### REMARKS

**AMENDMENTS TO THE DRAWINGS:**

FIG. 1

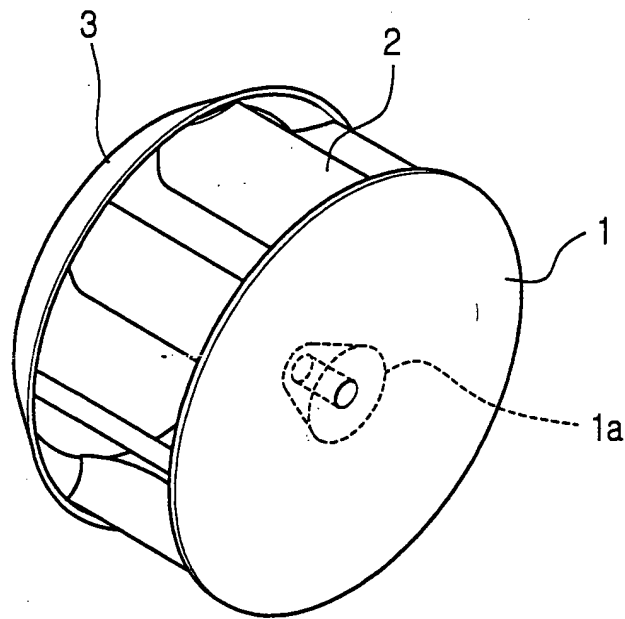
On page 2 of the Office Action, the Examiner objected to the drawings because these drawings did not include the legend –PRIOR ART--. In order to overcome these objections, replacement figures are submitted herewith. For the convenience of the Examiner, annotated sheets showing the changes made are also attached. In FIGS. 1 and 2, the legend – PRIOR ART—has been added. Approval of these changes to the Drawings and withdrawal of the objection to the drawings is respectfully requested.

The attached drawing(s) include changes to FIGS. 1 and 2. The sheet containing FIG. 1 replaces the original sheet including FIG. 1, and the sheet containing FIG. 2 replaces the original sheet including FIG. 2. In FIGS. 1 and 2, please ADD the legend –PRIOR ART–.

PRIOR ART
